National Committee on Uniform Traffic Control Devices

TECHNICAL COMMITTEE: NCUTCD Bicycle Technical Committee

Revised Design:

M1-9 US Bicycle Route Marker

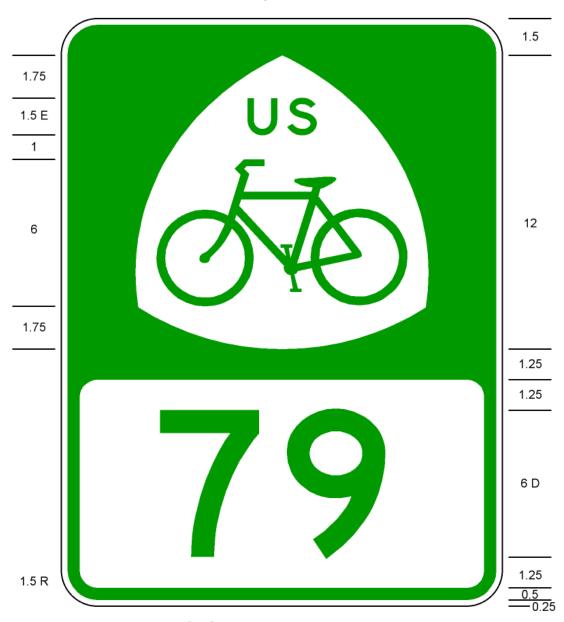
The BTC and GMITC showed a strong preference for the negative-contrast design, so this design was brought forward as the final version of the redesigned M1-9. The selected design also greatly reduces the possibility that the sign design might be confused with a D10-4 enhanced reference marker (although the mounting of this sign would make such confusion highly unlikely in the first place).

M1-9 US Bicycle Route Marker Size: 18" x 24" (roadway) or 12" x 18" (path) White on green

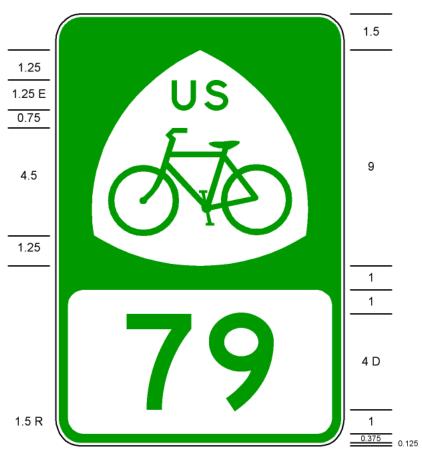
The NCUTCD Bicycle Technical Committee, in conjunction with the NCUTCD Guide & Motorist Information Sign Technical Committee, proposes that the M1-9 shield shown in Figure 9B-4 of the MUTCD be replaced with the following:

All text / symbols centered

SHS layout (18" x 24" size)
